Causal pulse shape and tap limits

(comments I-468 , R1-282 and R2-204)

Piers Dawe

Content of dawe 3ds 01 260527 or 3dk dawe 2511 1

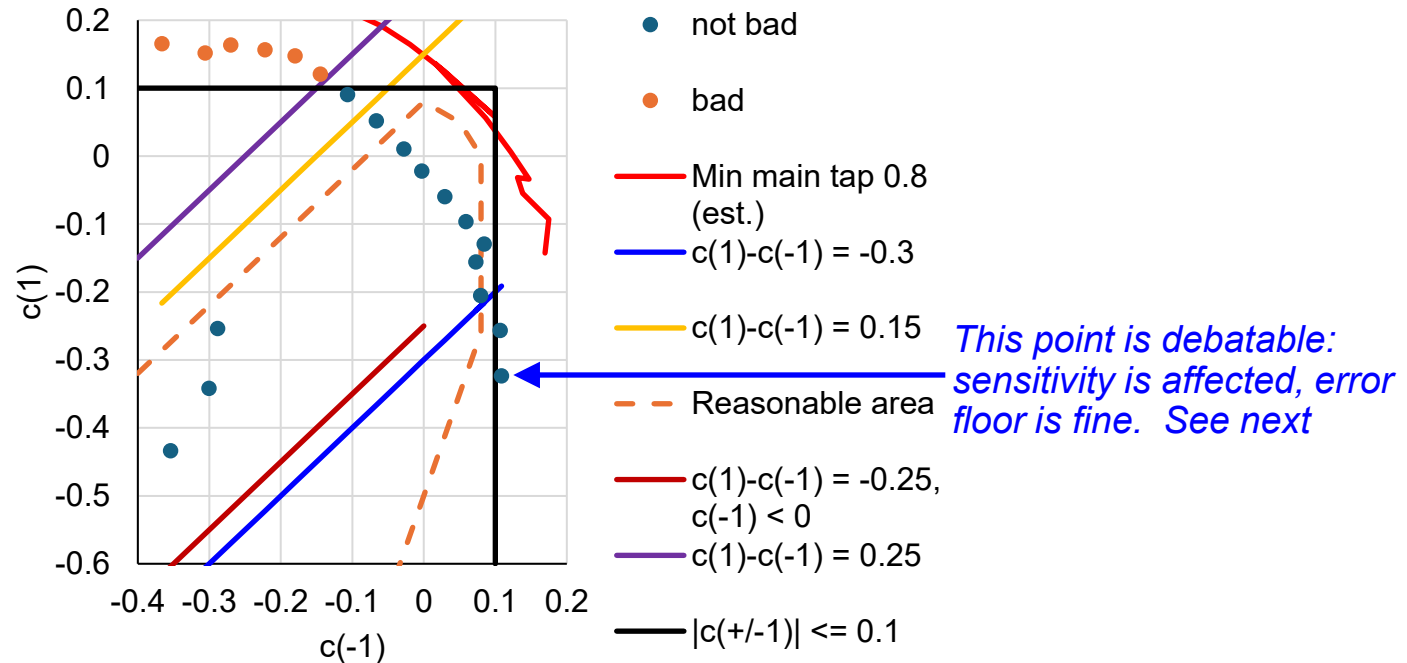
- P802.3ds D1.1 comment 113 193 SC 193.9.7.1 P 71 L 27 TR
- Causal vs. anticausal pulse shapes
This pre-post equalizer coefficient difference limit $|w(1)/w(0) - b(1) - w(-1)/w(0)|$ seeks to keep the attack and decay of the signal pulse similar. Yet the evidence from https://ieee802.org/3/dj/public/25_05/chayeb_3dj_01_2505.pdf#page=8 and 9, plotted in https://ieee802.org/3/ds/public/Interim_May_27-28-2026/dawe_3ds_01_260527.pdf, shows that for a real receiver, the situation is far from symmetrical; relatively fast attack ($c(-1)$ close to zero) and slow decay ($c(+1)$ strongly -ve) is tolerated well, but the opposite is not. Note that some acceptable signals on chayeb page 9 remembering are off the bottom of the plot in [dawe_3ds_01_260527](https://ieee802.org/3/ds/public/Interim_May_27-28-2026/dawe_3ds_01_260527.pdf).

- Remove the absolute bars $| |$, and replace the dash in the minimum column with -0.4, so that the allowed range becomes -0.4 to +0.25.
If necessary, state that this row is a constraint, just like the other tap limits (if there is a solution that fails this rule, and there is another solution that passes all the rules, that's a pass). But don't try to write out a constrained optimiser in the draft; it could be quite complicated and it's T&M implementation that should not appear in a standard anyway.

- **ACCEPT IN PRINCIPLE.** Set the pre-post equalizer coefficient difference limit $-0.4 < w(1)/w(0) - b(1) - w(-1)/w(0) < 0.25$.

Cost of force-fitting post-pre tap difference

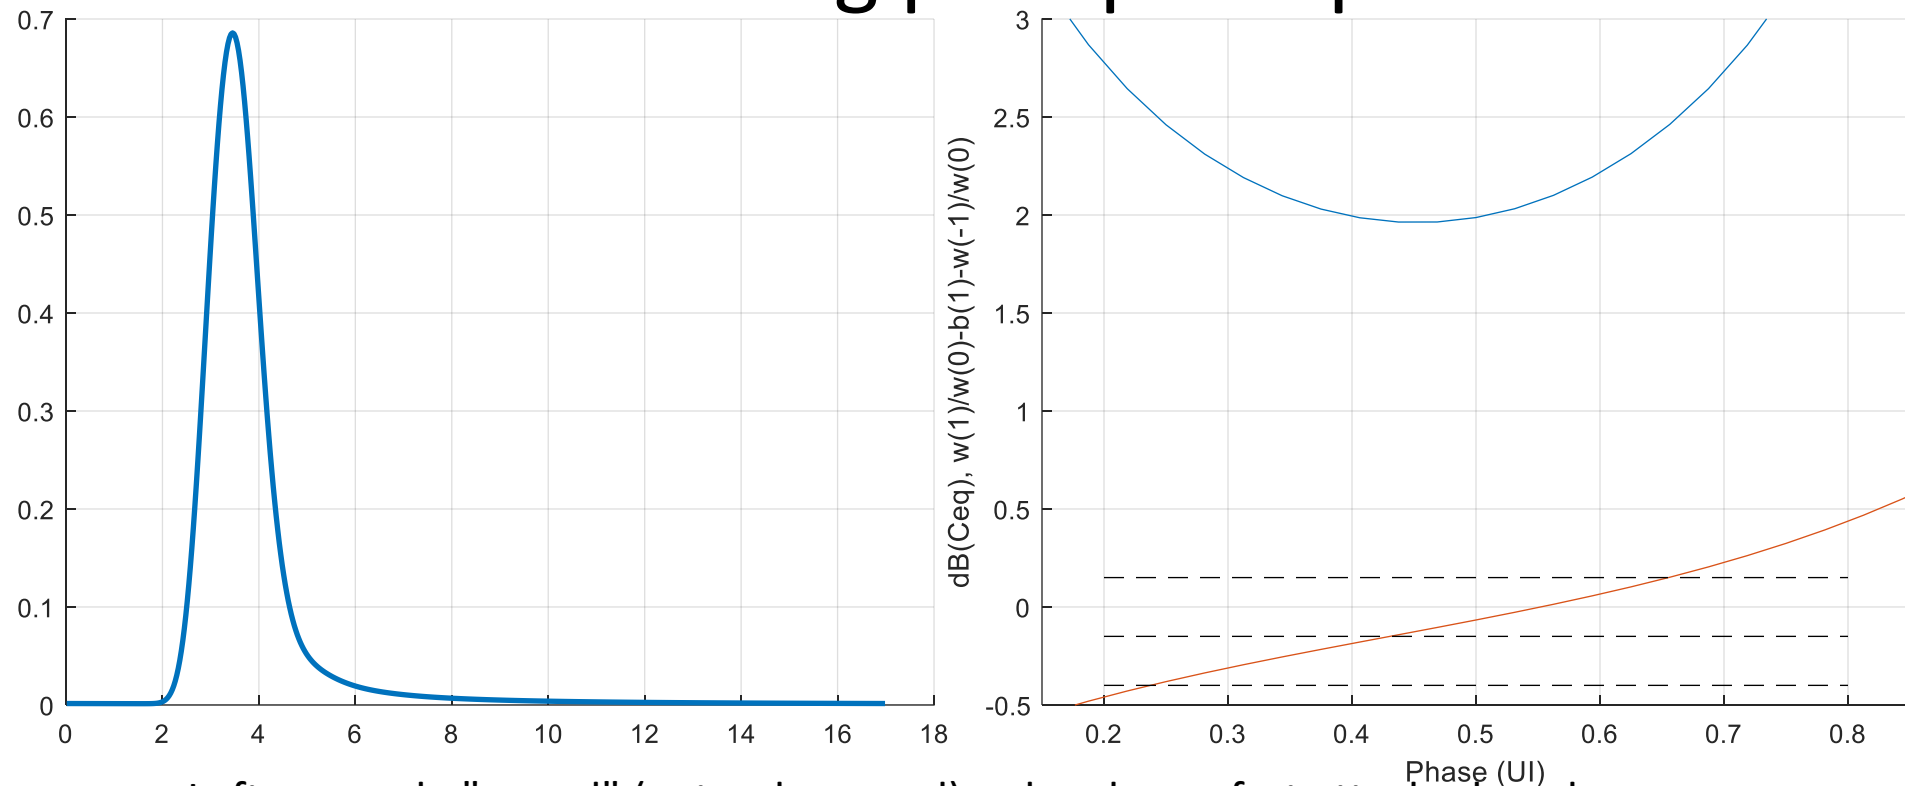
- Left: example "causal" (natural, normal) pulse shape: fast attack, slow decay
 - More skew than this is commonplace
- Right: sweeping sampling phase. Best is ~ 0.45 UI where post-pre is almost -0.15 UI. This is a very ideal simulation; in practice the sweet spot would be narrower
- There is equal timing offset penalty at -0.25 UI and 0.67 UI where post-pre is -0.4 and $+0.15$
- The proposed limits are a significant improvement
